ASOS MODIFICATION NOTE 20 (for Electronics Technicians)

SUBJECT ACU Memory Firmware Version 2.2 and ACU CPU Firmware 1.81 :

PURPOSE To add GS-200 communication enhancements for the ASOS

EQUIPMENT AFFECTED: ASOS Acquisition Control Unit (AACU)

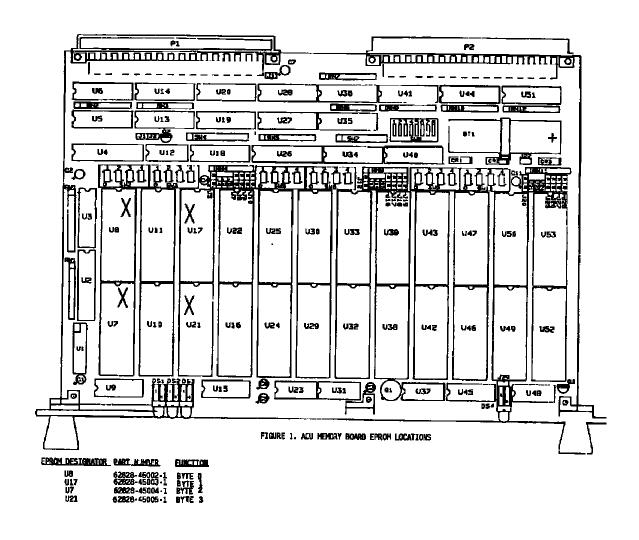
All ASOS application software is contained on the four erasable programmable read only memory (EPROM) integrated circuits (IC) on ACU memory board 1A2A3. Figure 1 illustrates the ACU memory board and identifies the four EPROMs (U8, U17, U7, and U21). The EPROMs are 32-pin dual in-line package (DIP CMOS devices, each providing 512K x 8 bits of storage. Upgrading ASOS software requires only replacing the dual in-line package (DIP) four EPROMs on the ACU memory board with higher revision level ICs.

- 8. From the front of the board, slide small flat blade screwdriver between integrated circuit **u7** and its IC socket. Carefully lift up on U7 to remove it from the socket as evenly as possible. After U7 is removed from the socket, place in a conductive foam or on some other static-free surface.
- 9. Repeat Step 8 for removal of the following integrated circuits U8, U17 and U21.
- 10. Remove U29 and U30 from the ACU CPU printed circuit boards 1A2A1 and 1A2A2 sockets and place the removed integrated circuits in a conductive foam or on some other static-free surface.
- 11. Using the IC insertion tool, remove the new EPROM ICs from protective packaging and insert them into the ACU memory board sockets in accordance with the following chart. Ensure that the EPROMs are installed with pin 1 (as identified by notch in top of IC) oriented toward board connector P1 and P2 as shown on Figure 1.

IC socket	IC part number
<u>U8</u>	62828-45002-1
U17	62828-45003-1
U7	62828-45004-1
U21	62828-45005-1

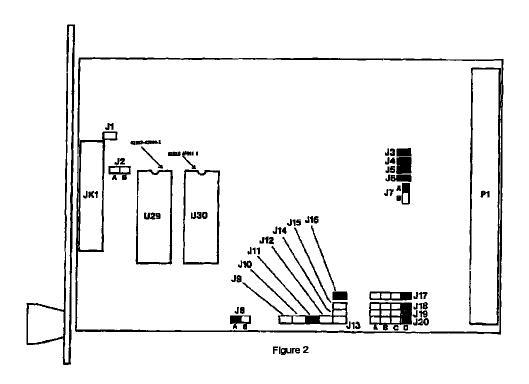
All pSOS ASOS application software is contained on the four EPROM ICs on the ACU CPU board IA2AI and IA2A2. Figure 2 illustrates the ACU CPU board and identifies the two EPROMs (U29 and U30). The EPROMs are 28-pin DIP CMOS devices, each providing 256K x 8 bits of storage. Upgrading pSOS ASOS software requires only replacing the two EPROMs on the ACU CPU board with higher revision level ICs.

- 12. Use a small flat blade screwdriver, and install the three flat washers and screws. This will secure the front panel to the board.
- 13. Hold the ACU memory board by handles, position the board with the component side facing to the right and carefully slide board into VME rack on its guides. Align the board with the rear connector and press into place.
- 14. Use a small flat blade screwdriver and tighten the captive screws located at top and bottom of board.
- 15. Remove the new EPROMs ICs from the protective packaging. Use an IC insertion tool to insert the EPROMs into the ACU CPU board's sockets (1A2A1 and 1A2A2) in accordance with the following chart. Ensure that all the EPROMs are installed with pin 1 (as identified by notch in top of IC) oriented toward the top of the ACU CPU board as shown on Figure 2

<u>IC socket</u> <u>IC part number</u> 029 62828-45000-1
